# Whitehorse City Council Submission

## Activity Centre Program – Phase 2 consultation on Draft Maps for Blackburn, Nunawading and Mitcham

19 March 2026

**Figure 5: Blackburn Activity Centre – 3D Built Form Analysis**  
 Source: Council modelling, Whitehorse Activity Centres Built Form Scenario Testing

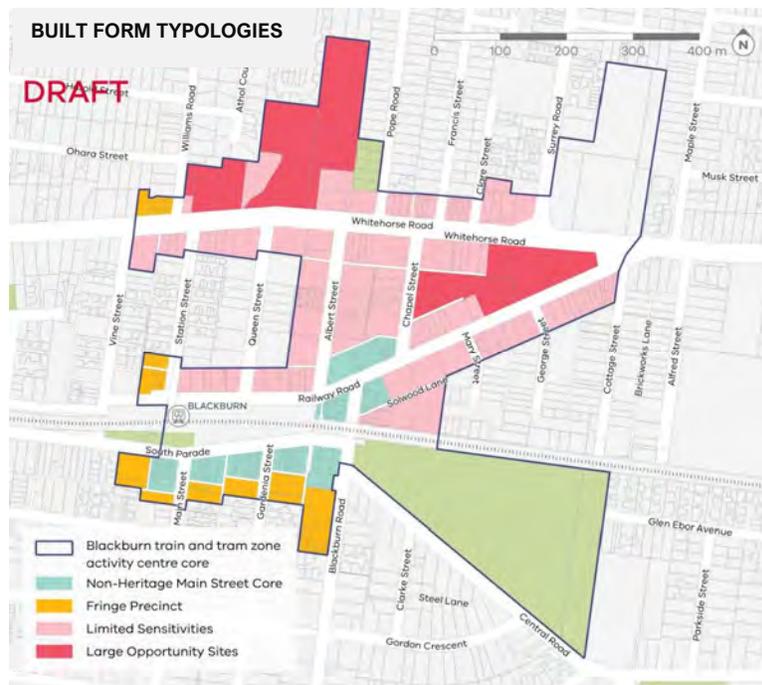
Council recently conducted a 3D built form modelling analysis of the Blackburn Activity Centre core (Figure 5), using DTPs set “Built Form Typologies” and then incorporating tests of local variations. **Overall, the Department proposed typologies for the Blackburn Activity Centre core (Map 5) are generally supported by Council; however, Council does not support the scale of the development subsequently applied and as reflected in the state government’s proposed Draft Plans, as this is considered inconsistent with the local “Village” context, and the desired outcomes for sensitive growth in Blackburn.**

**Figure 7: DTP Proposed building heights of up to 12 storeys along the South Parade**  
 Data accessed via Engage Victoria

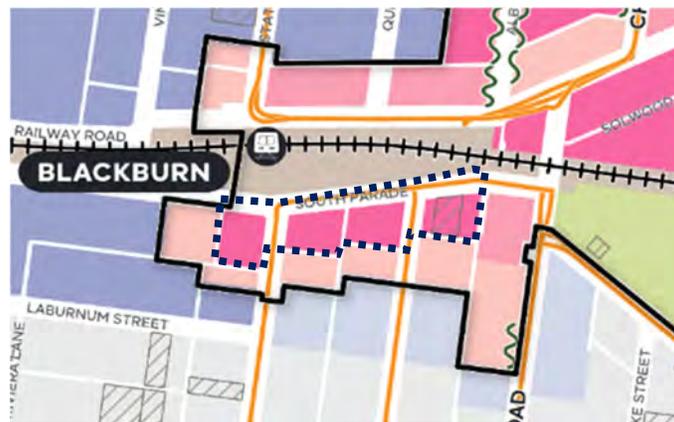
While a “Non-Heritage Main Street Core” Built Form Typology designation<sup>6</sup> is appropriate for this location, **it is recommended that building heights along South Parade be limited to 8 storeys** (the maximum height identified for the “Non-Heritage Main Street Core” typology in centres with HGI:2, as shown in Table 4, page 22), and **properties behind them should be limited to 6 storeys (Fringe Built Form typology), followed by a transition to 3 storeys within the Outer Catchment.**

This stepped height arrangement would provide a clear and appropriate transition toward the 3-storey Outer Catchment areas, maintaining compatibility with the fine-grain character of the South Parade and minimising potential adverse impacts on the streetscape.

**Figure 8: Proposed Extensions to Landscape / Building Setbacks in the Blackburn Activity Centre Core**

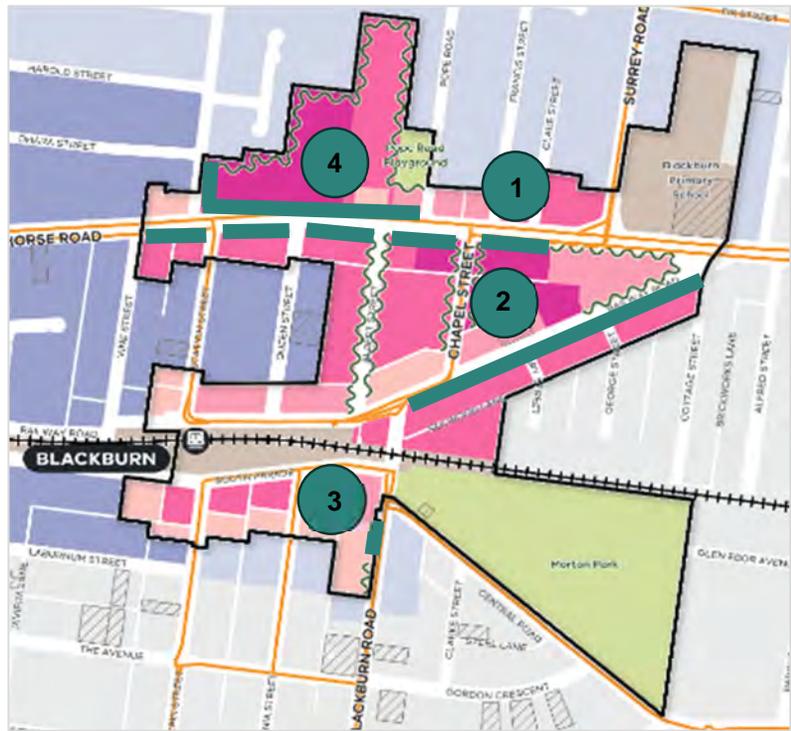
For example, according to the Foundation Maps provided for the Blackburn Activity Centre core, **additional landscaped / building setbacks are required for certain streets beyond those currently proposed**, including Albert Street, Chapel Street, portions of Railway Road, and Whitehorse Road. These setbacks are needed to accommodate deep soil planting and canopy trees, support improved pedestrian amenity, and contribute to the overall character and usability of the public realm. They also help create sunny, active streets, reinforce human-

1. South side of Whitehorse Road, extending the proposed setback
2. South side of Railway Road, to provide greater public realm space.
3. West side of Blackburn Road, extending to South Parade.
4. North Side of Whitehorse Road (Between Williams Road and Pope Road)

These proposed extensions to landscaped / building setbacks are sought to enhance the streetscape, improve pedestrian amenity, and ensure that built form is appropriately responsive to the local context.

Figure 12: Proposed Extensions to Landscape / Building Setbacks in the Nunawading Activity Centre Core

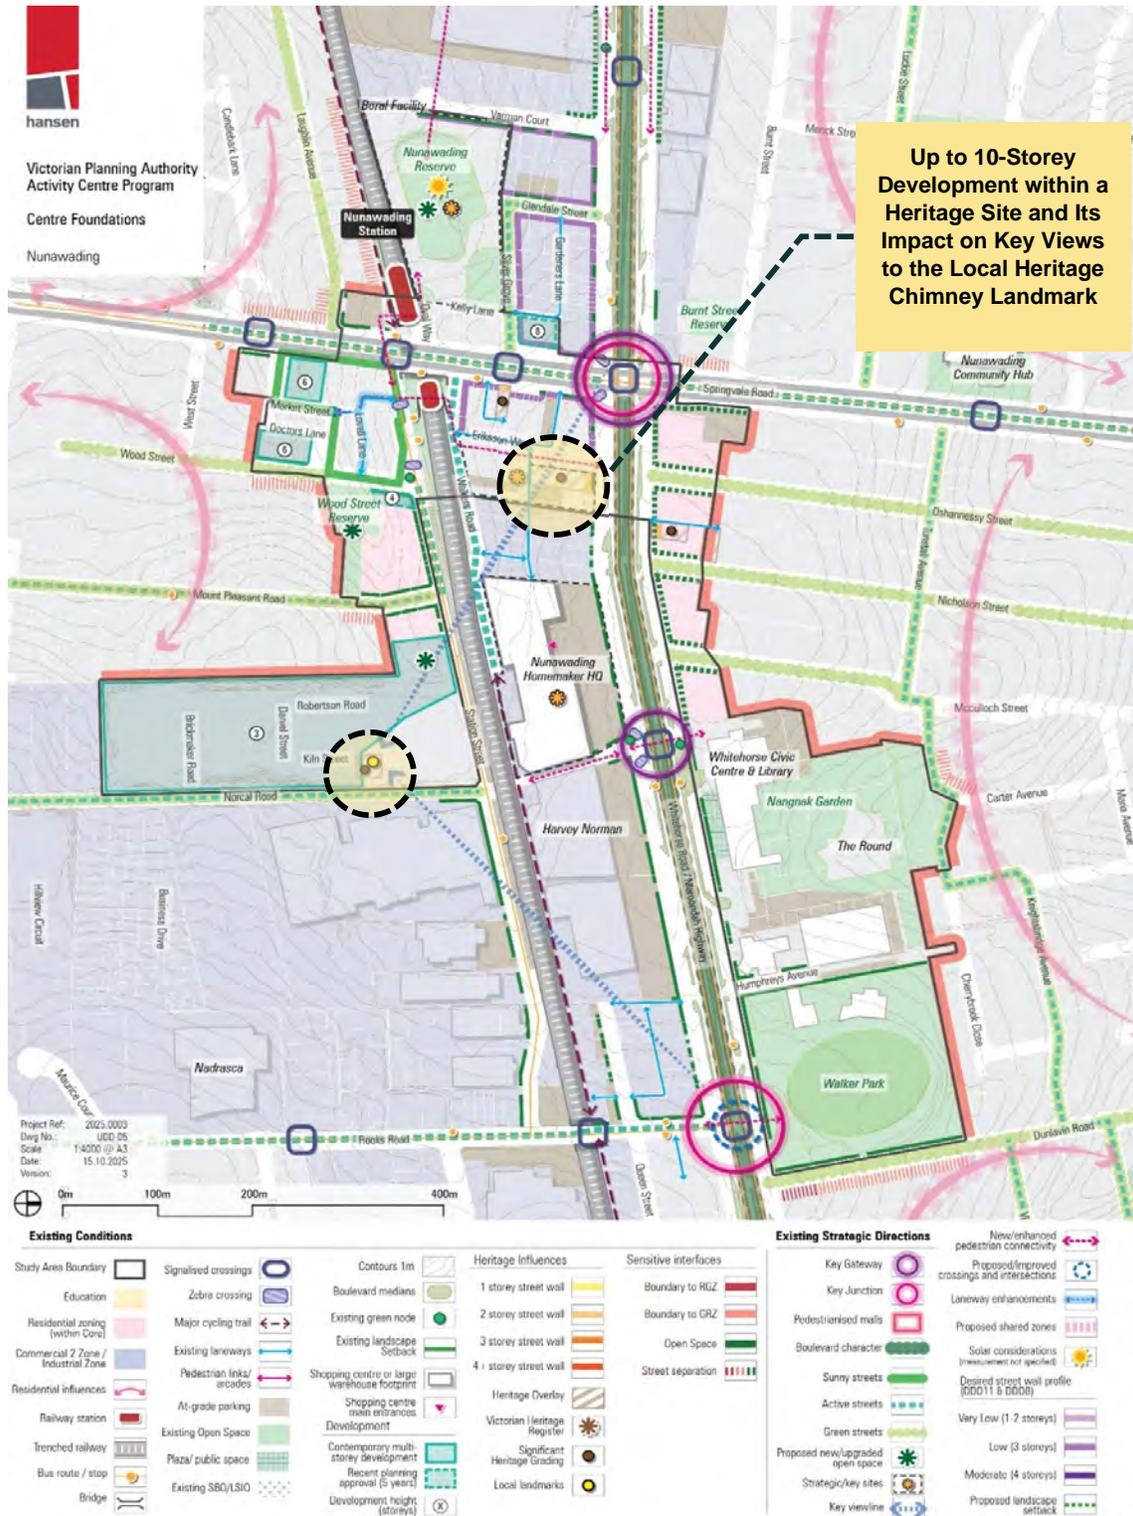
In recognition of this, **Council recommends that a “High Protection” designation be applied to Wood Street Park, corresponding to mandatory sun access protection<sup>7</sup>, to safeguard its ongoing amenity and public value. To support this objective, Council proposes that maximum building heights for parcels immediately north of the park be reduced, and wider landscape setbacks considered**, ensuring a buffer that both mitigates overshadowing and enhances the park’s public realm (Figure 12).

**Map 11: Proposed Building Heights, Mitcham Activity Centre Core,**  
 Data accessed via Engage Victoria

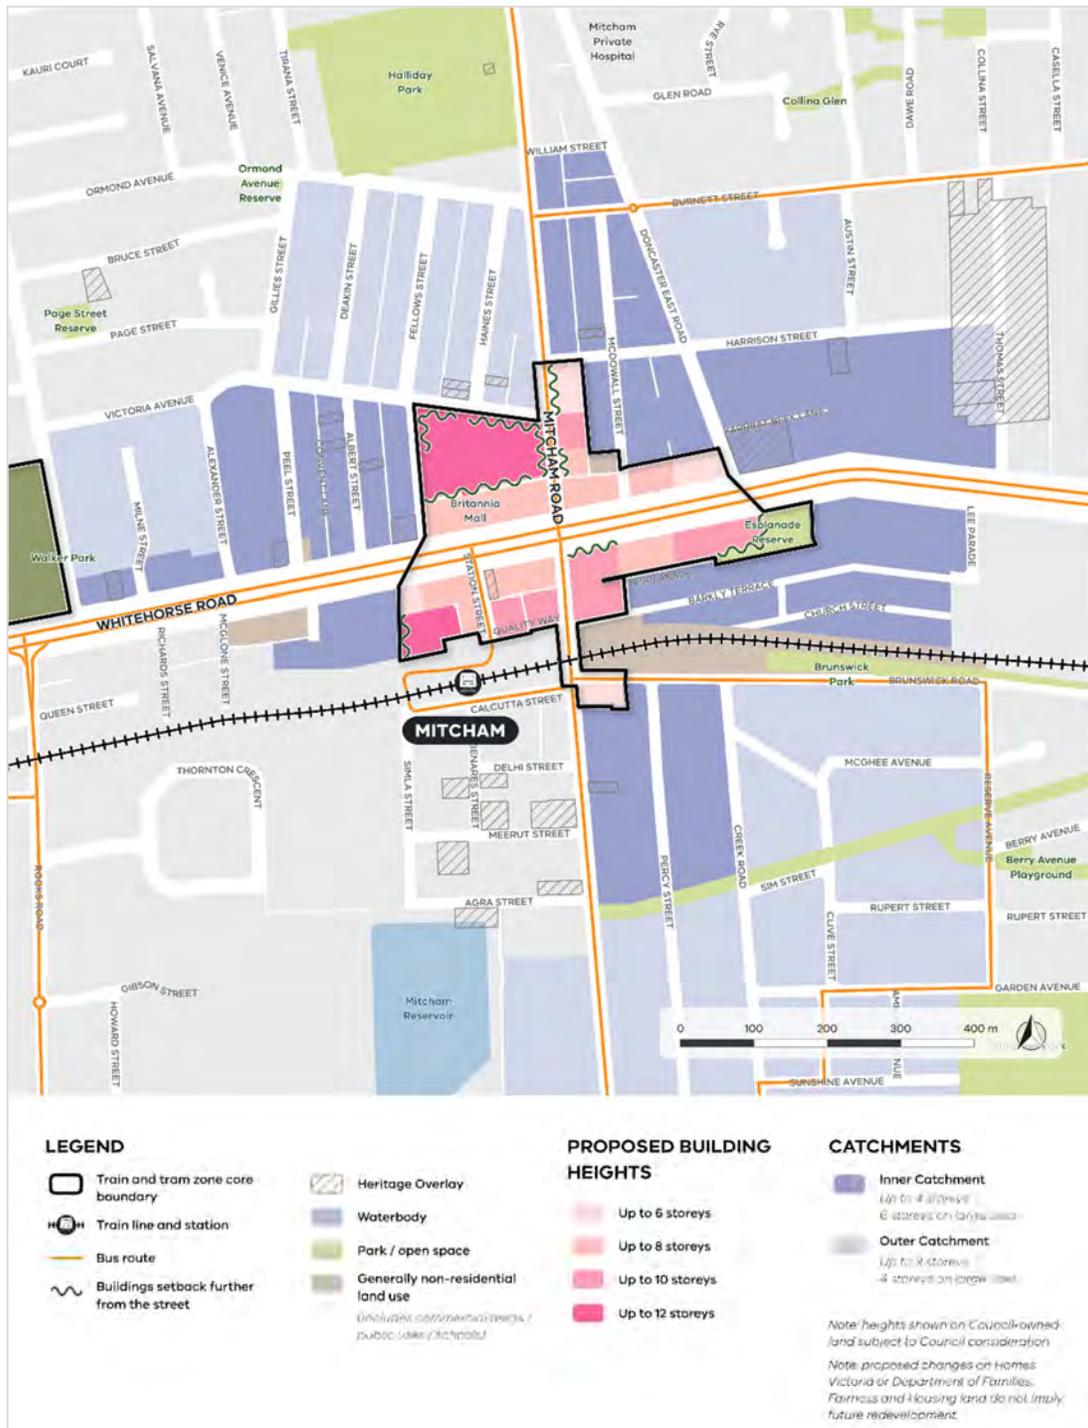
The maximum proposed building height within the Mitcham Activity Centre is 12 storeys on select sites, while most areas within the core are generally anticipated to range between 8 and 10 storeys (Refer Map 11).

As with Blackburn and Nunawading, based on the materials released to date, there is no clear evidence that the Local Variations Assessment, including detailed place-specific testing and refinement, has been undertaken or transparently demonstrated by DTP. The absence of documented local variation testing raises concern that the proposed controls reflect a standardised application of typologies rather than a calibrated response to site-specific constraints and opportunities.

**Figure 13: Solar Analysis, Britannia Mall, Mitcham**

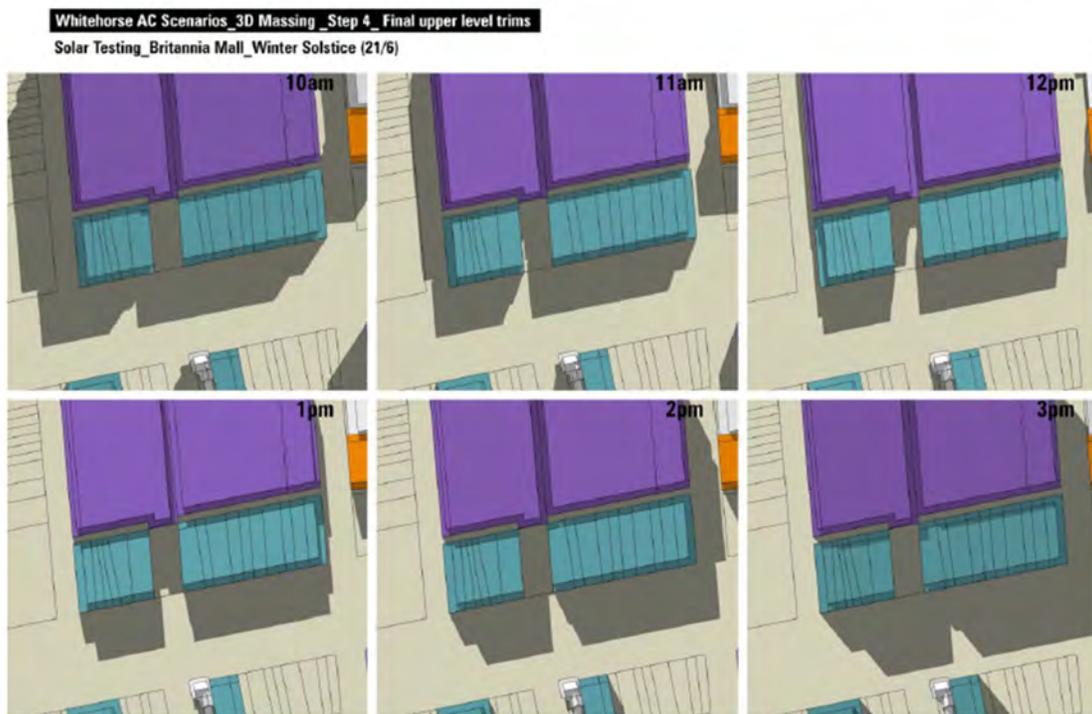
Overshadowing analysis undertaken by Council for the winter solstice (21 June), between 10 am and 2 pm, indicates that the public realm of Britannia Mall would be largely in shadow for most of this period, with only a small portion receiving sunlight at 12 pm. This represents a significant departure from the existing conditions, where the mall currently benefits from meaningful sunlight access between 11 am and 2 pm due to lower adjacent building heights and the limited scale of development at the existing Mitcham Shopping Centre site (Refer Figure 14).

Notwithstanding this, the Department of Transport and Planning has proposed building heights of up to 8 storeys along Whitehorse Road and up to 12 storeys on the northern large opportunity site, which would further increase overshadowing of the mall, other public realm (such as footpaths) and adjoining residential areas particularly in the vicinity of the large development sites on Edward Street. The interface of Victoria Crescent has a sensitive interface to the Neighbourhood Residential Zone area to the north which should also be considered.

**Council considers it necessary that the proposed setbacks on the large opportunity site on the eastern side of Edward Street be extended** to provide a more appropriate transition to the adjoining residential areas. Further, that consideration be given to appropriate **setbacks and building presentation to Victoria Crescent** as a sensitive interface.

**Figure 16: Visual Impact Assessment on Heritage Site in Mitcham (Former Post Office)**  
 Source: Council modelling, Whitehorse Activity Centres Built Form Scenario Testing

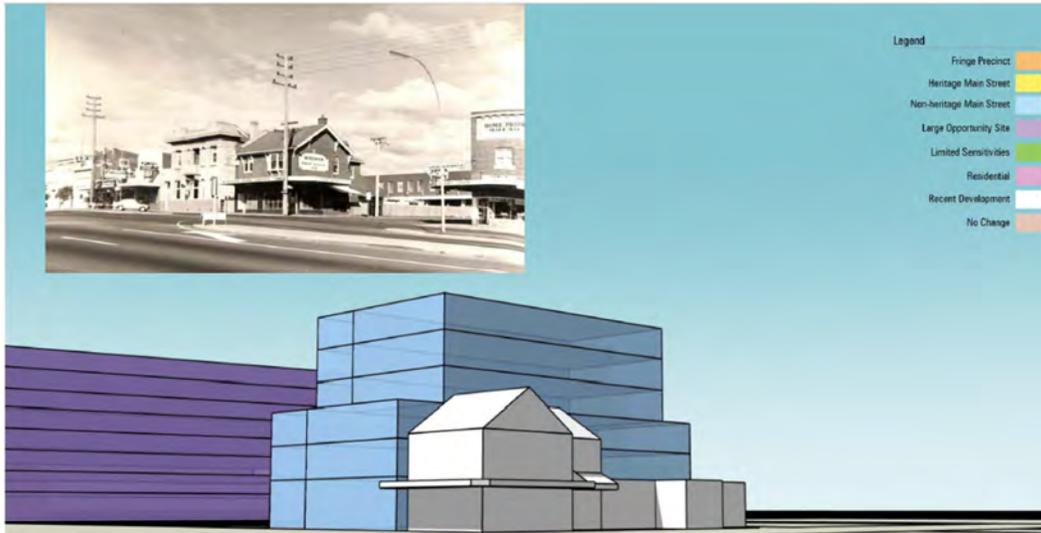
Council’s visual impact assessment was undertaken on a 6-storey form, reflecting a more conservative approach to evaluating potential impacts on the heritage setting (Refer Figure 16). Notably, even at 6-storeys, the assessment demonstrates a significant visual impact on the heritage place, highlighting that an 8-storey form would likely exacerbate these effects and further diminish the prominence and legibility of the Post Office within the Whitehorse Road streetscape.

As shown above, the proposed street wall and setback controls, as currently articulated, may not sufficiently address issues of visual dominance, scale transition, and potential impacts on the heritage setting.

Accordingly, Council considers that further clarification and more tailored urban design controls are required where proposed typologies interface with context-sensitive sites and key public realm assets within Mitcham. These include heritage and community landmarks such as 559–561 Whitehorse Road (Church), 556–572 Whitehorse Road (Mitcham Hotel), 528 Whitehorse Road (Former Post Office), and 469–471 Whitehorse Road (Church), as well as important open space and landscape interfaces including Esplanade Reserve.

**Figure 18: Council-proposed properties for the Nunawading Activity Centre Core**

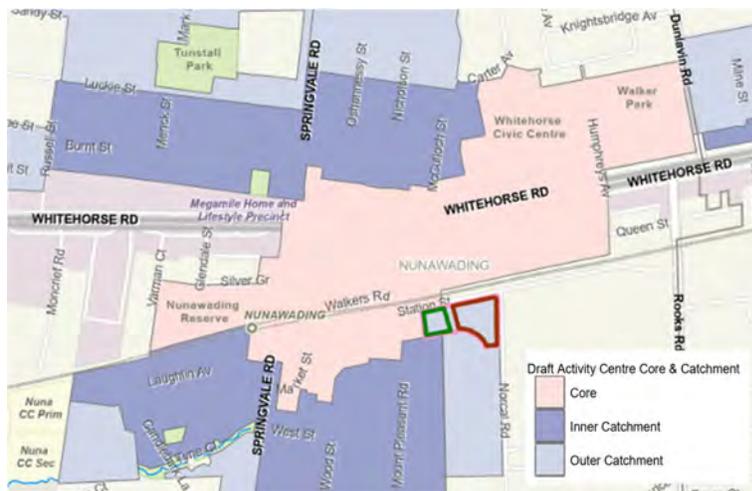
Council considers the inclusion of these sites within the core boundary to be appropriate in order to safeguard solar access to the open space and to support balanced development along the railway corridor, while ensuring integration with the broader activity centre.

**Figure 19: Proposed Changes to the Blackburn Activity Centre Catchments**

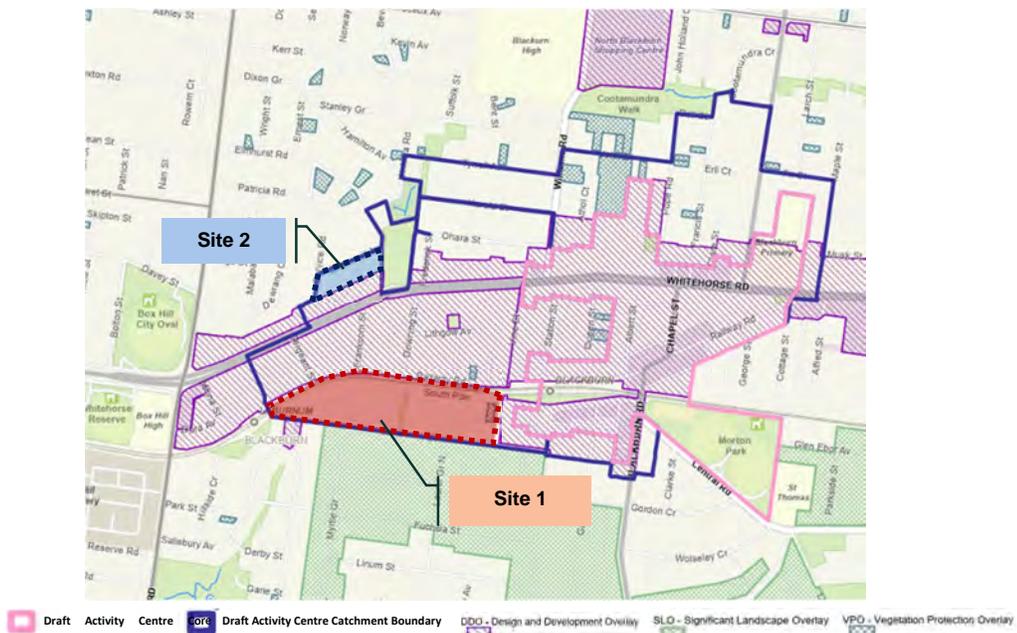
In Blackburn, this intended transition does not consistently occur. There are also only two primary catchment locations: the outer catchment to the north which directly adjoins the core, and a significant inner catchment that extends to the west of the centre. This configuration creates interface challenges, particularly between areas permitting up to 4 storeys and larger sites capable of accommodating up to 6 storeys along Laburnum Street and its interface with SLO2 and NRZ1 areas to the south of Laburnum Street (Refer to site 1 in Figure 19).

Likewise, **the reach of the inner catchment to properties in Broomhill Avenue and north of O'Hara Street is excessive; these areas are a long walking distance from the station and should be in the outer catchment to create a more reasonable transition** (Refer to site 2 in Figure 19).

**Figure 21: Blackburn Activity Centre – Sensitive Interfaces and Proposed High-Rise Development Controls**

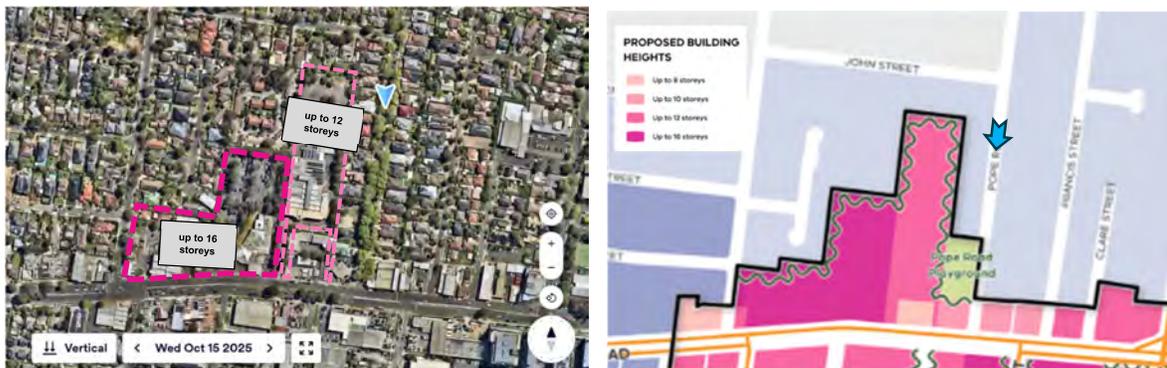
A master planning process on large opportunity sites within the Blackburn Activity Centre core, such as the Blackburn Hotel and Sikh Temple sites which interface with existing residential areas (Refer Figure 21), will be important to ensure context-sensitive built form, appropriate height transitions, and mitigation of visual bulk and overshadowing. In their current form, the

Additionally, Council continues to seek a reassessment of the Housing Growth Index (HGI) for Blackburn, supporting moderate-density development with a maximum 12-storey limit for large opportunity sites, to balance housing growth with the protection of liveability and streetscape character. For example, under HGI:2 sites shown in figure 21 as 16 storeys would reduce to 12 storeys. (e.g. the Blackburn hotel site).

**Figure 24: Significant Landscape Overlay 11 (Amendment VC278) within Whitehorse Activity Centres**

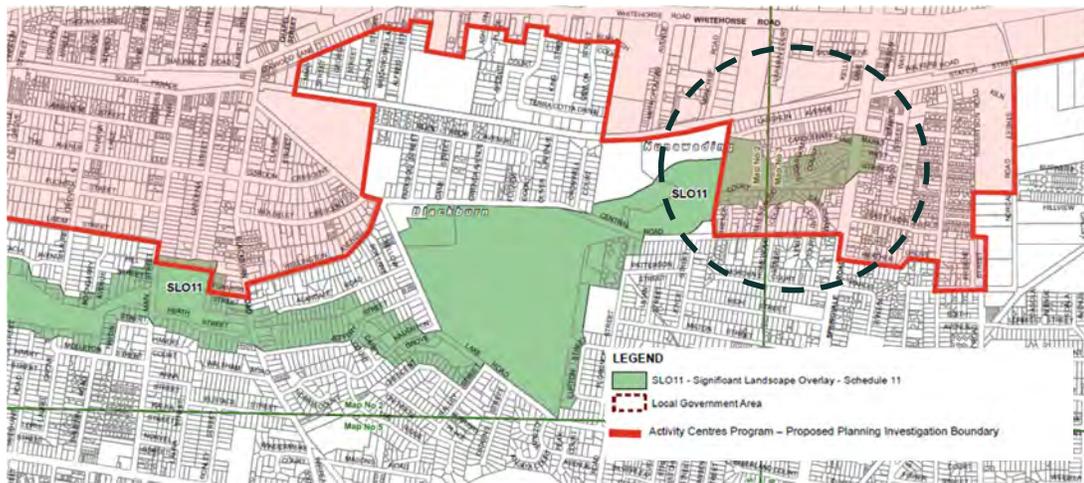
Council has concerns regarding the impact on SLO11 within the Nunawading inner catchment boundary, particularly along Newburn Reserve and parts of Market Street and West Street (Refer Figure 24). While the overlay seeks to protect landscape character and environmental

values associated with the adjoining waterway corridor, the application of the Housing Choice and Transport Zone (HCTZ) results in an exemption from the buildings and works permit trigger under Amendment VC278.
